## Post Operating Exam Comment #1

Scenario 2 Critical task 3 states:

## Post Operating Exam Comment #2

### Post Operating Exam Comment #3

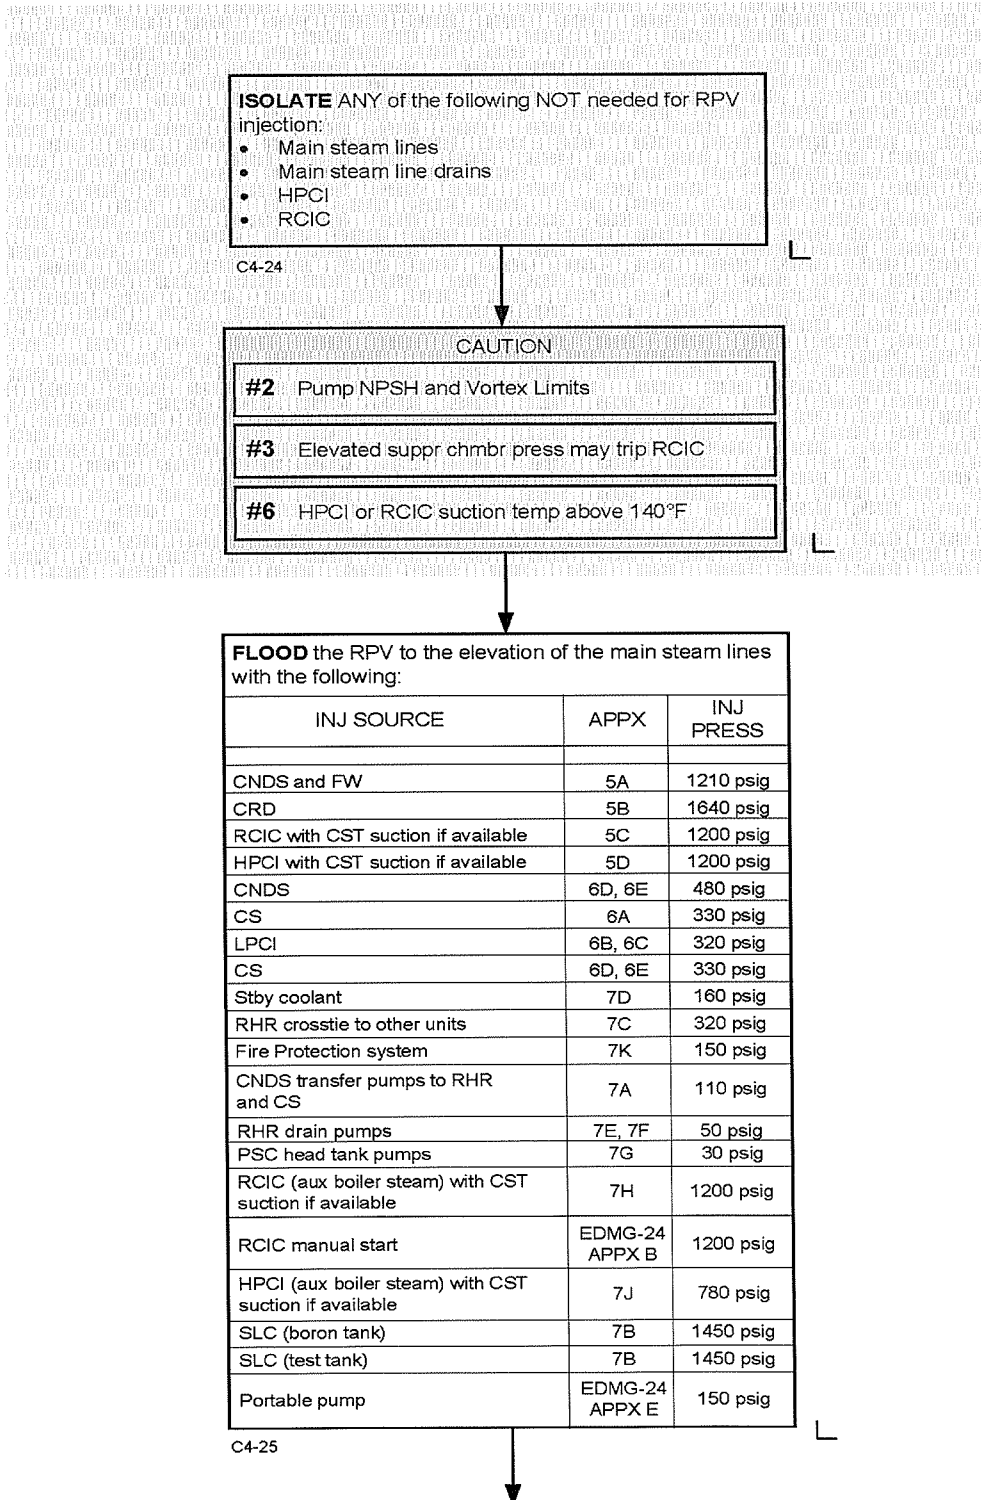
One of the Crews did not inject into the RPV with all available sources until one of the conditions in C-4, Note 7 is met.

EOI step C4-25 states: Flood the RPV to the elevation of the main steam lines with the following. It does not say to use all available sources.

EOIPM Section 0-V-J Discussion of step C4-25 states:  
aligned to flood the RPV and establish core cooling by submergence. The list of flooding methods includes all sources capable of injecting into the RPV, including the "alternate injection subsystems" defined in EOIPM Section 0-I-C. Any or all of the listed methods may be used as necessary to flood the RPV to the elevation of the main steam lines.

The Facility recommends rewording the critical task as follows:

**After all RPV level instruments flash (level unknown), flood the RPV with any or all of the listed methods to the elevation of the main steam lines.**

See attached Plots of Reactor Power, Pressure, and Water level.

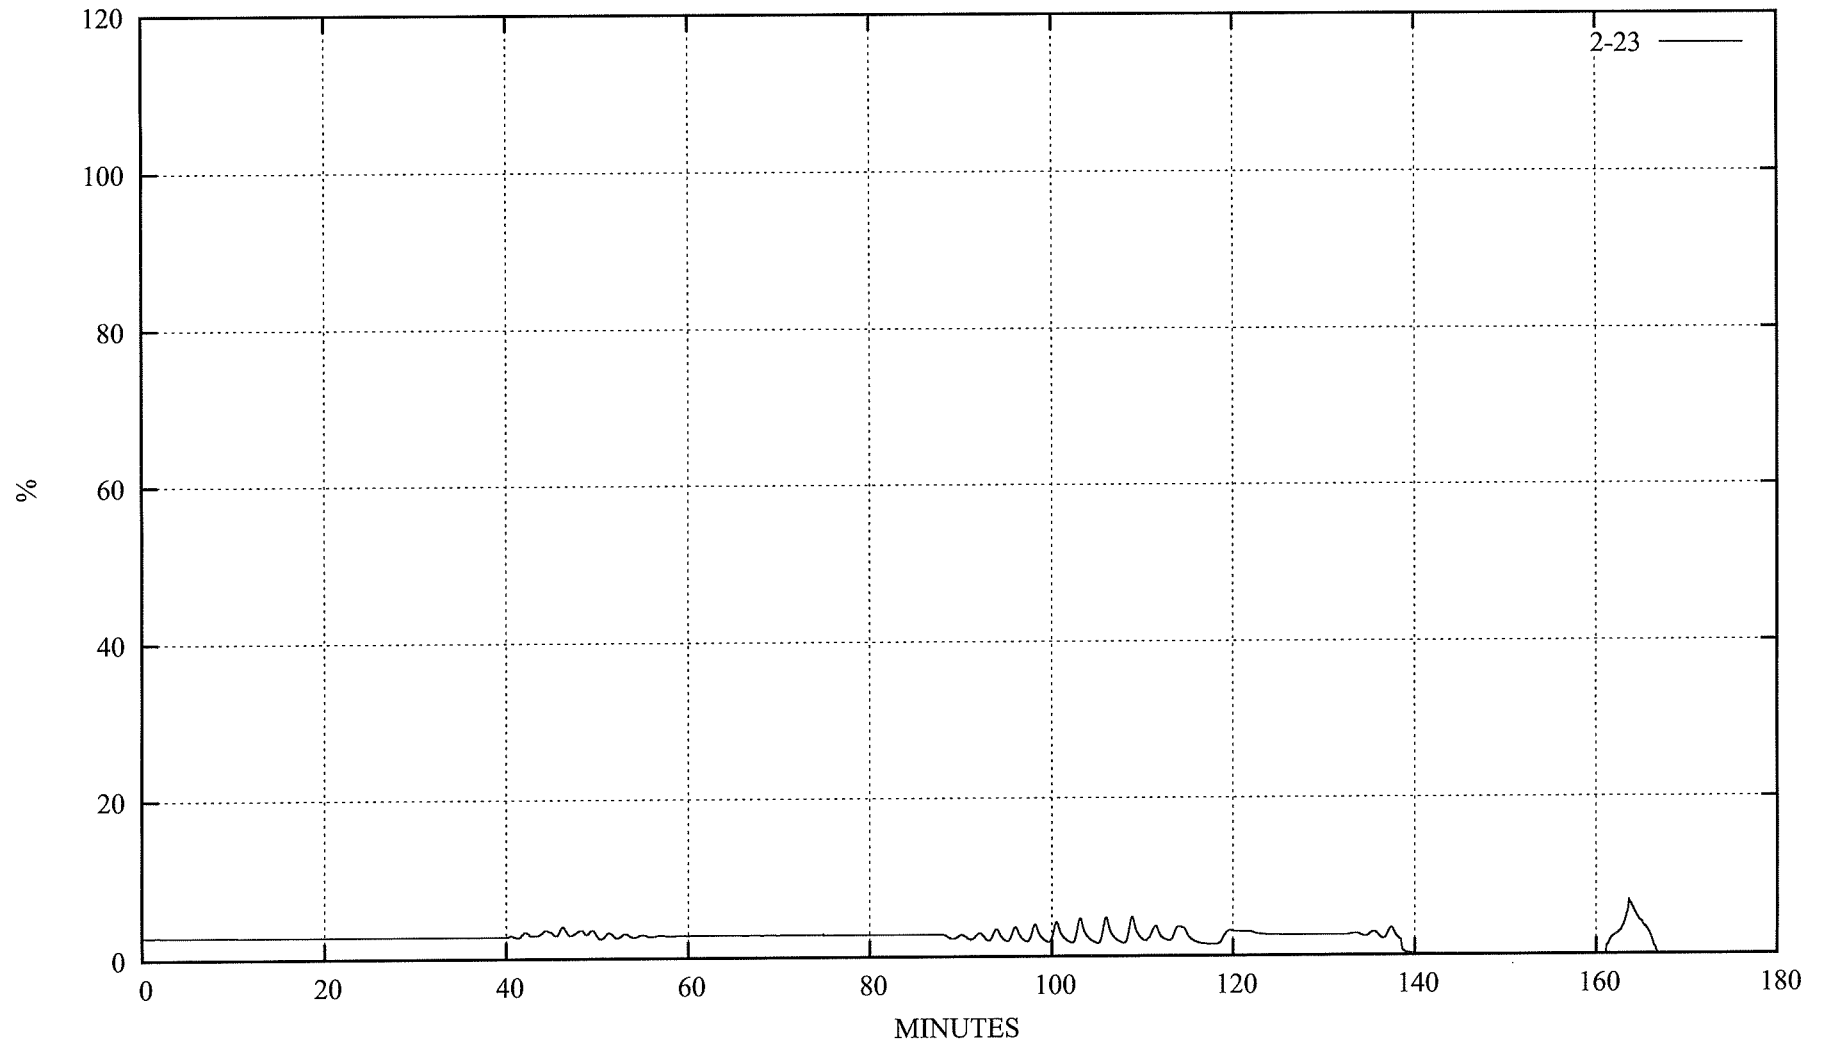
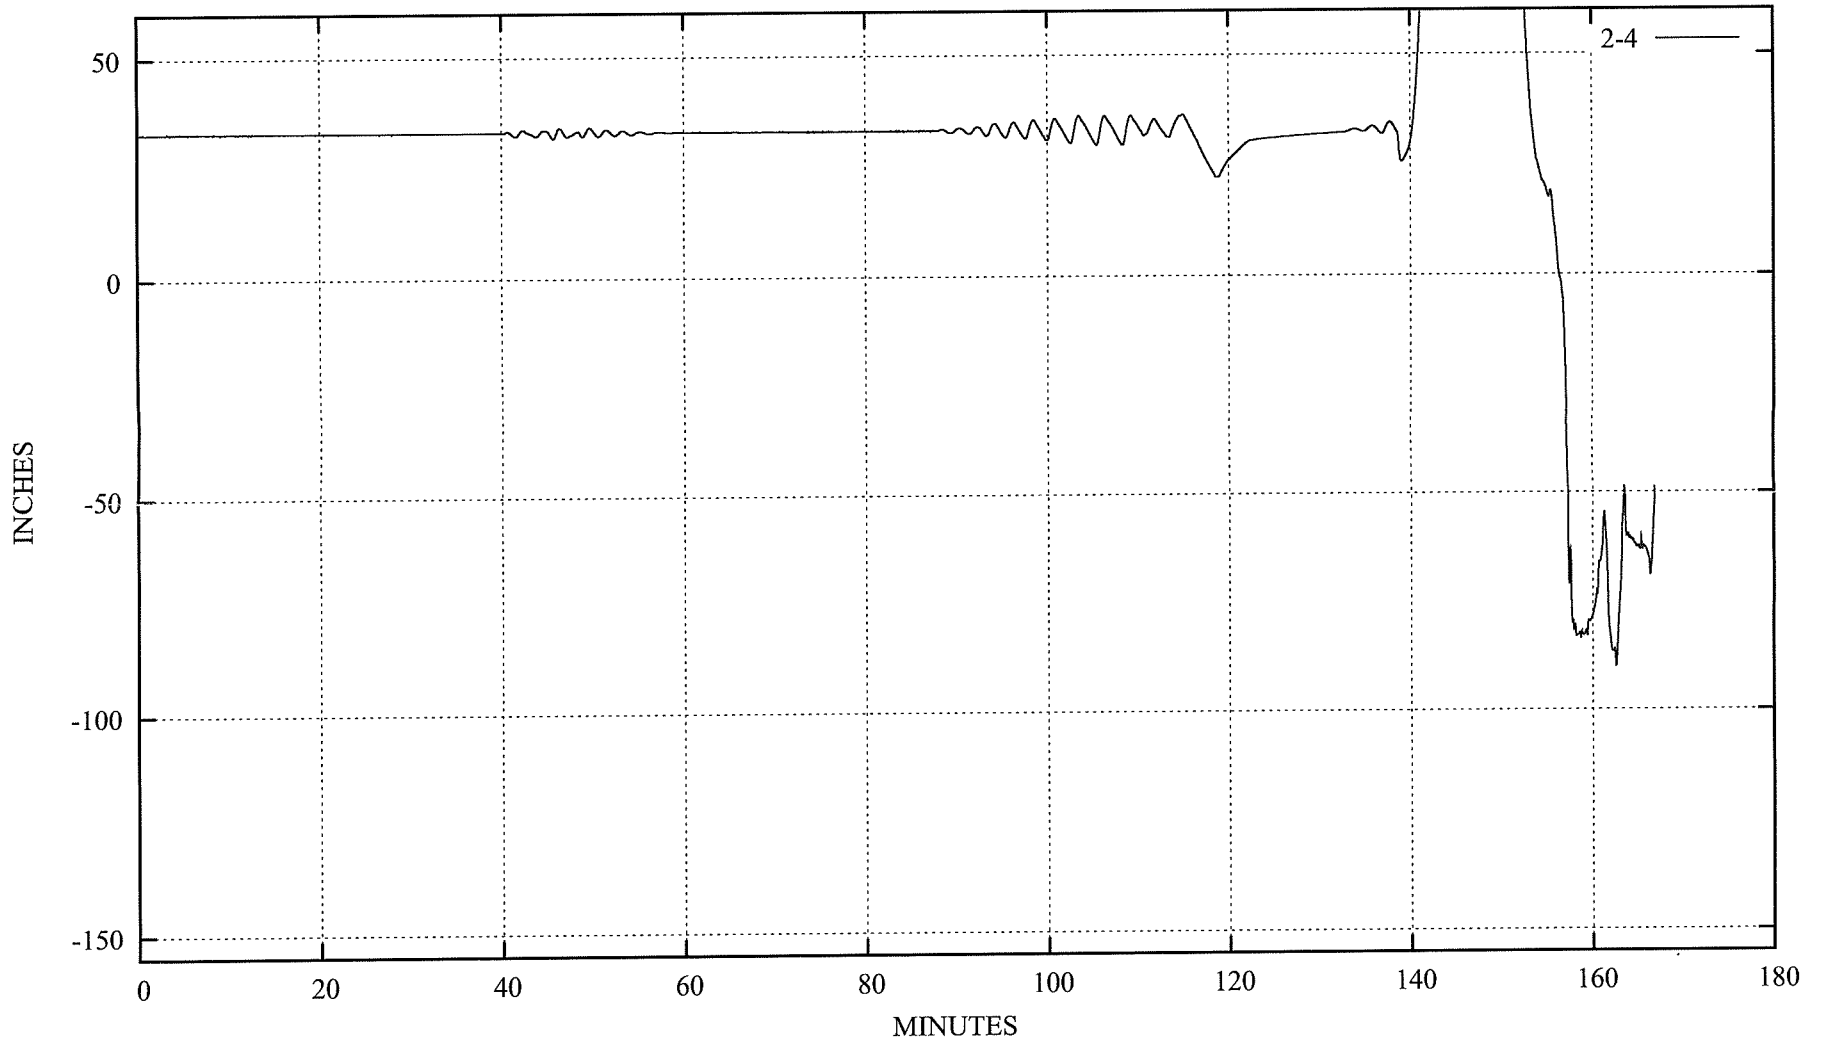
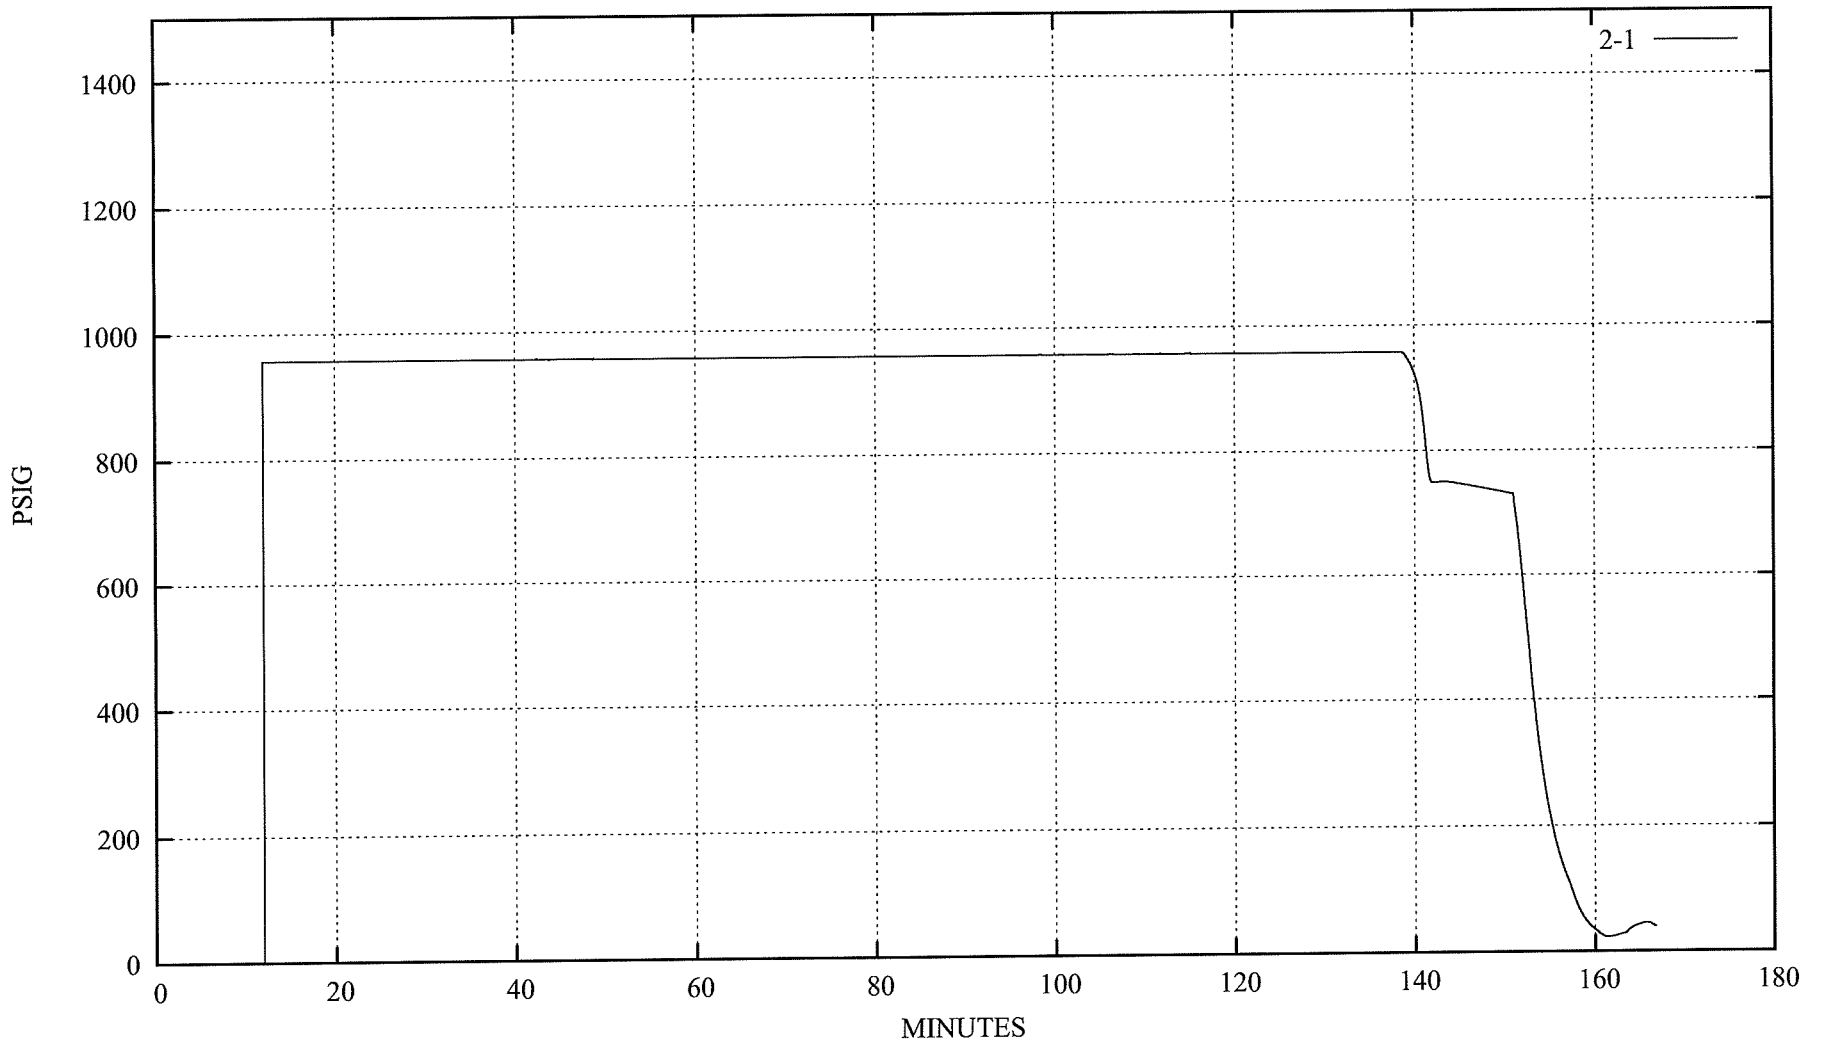
Crew B did terminate and prevent RPV injection from ECCS and Feedwater until reactor pressure was below the MSCP however; they did momentarily exceed the APRM downscale setpoint of 5% power once RPV injection was reestablished.

The Facility disputes this statement as bases for failing to meet this critical task. The actions required by the critical task and measured against the above listed “Measured by” criteria in the critical task were satisfied by the crew.

In accordance with EOI step C5-25 the Crew started injection in a controlled manner using only the Condensate system and increased flow using the startup bypass (throttle) valve to restore Reactor water level. Once the determination was made that Reactor water level could be restored and maintained above (-) 180 inches the crew was directed by step C5-28 back to C5-14 which was already completed.

**IF** Reactor power is above 5% or unknown **And** Reactor water level is above (-) 50 inches **Then** go to step C5-5. (Note that the APRMs could be above 5% and no action is required as long as Reactor water level is below (-) 50 inches, see EOIPM section 0-V-K). The Crew recognized that that Reactor power and Reactor water level were rising and injection was stopped prior to exceeding (-) 50 inches. Reactor water level lowered rapidly to approximately (-) 87 inches and the operator resumed injection with condensate. Reactor power momentarily exceeded 5% and Reactor water level reached (-) 50 inches. The conditions for step C5-5 were not meet because with Reactor pressure less than 50 psig above suppression chamber pressure the MSRVs would be closed. The crew immediately secured injection IAW C5-9 and Reactor water level immediately lowered to below (-) 50 inches allowing injection to the Reactor to be resumed IAW C5-10.

Based on C5 and EOIPM 0-V-K there was no Safety Significance to momentarily exceeding 5% power on the APRMs.

The facility recommends removing the statement below from the Critical task.

**During an ATWS, when conditions with Emergency Depressurization required, Terminate and Prevent RPV injection from ECCS and Feedwater until reactor pressure is below the MSCP, then restore and maintain Reactor water level above (-) 180 inches.**

This Critical task is not met if the crew fails to recognize and take action to secure injection to the Reactor if the conditions of C5-5 or C5-15 are met.
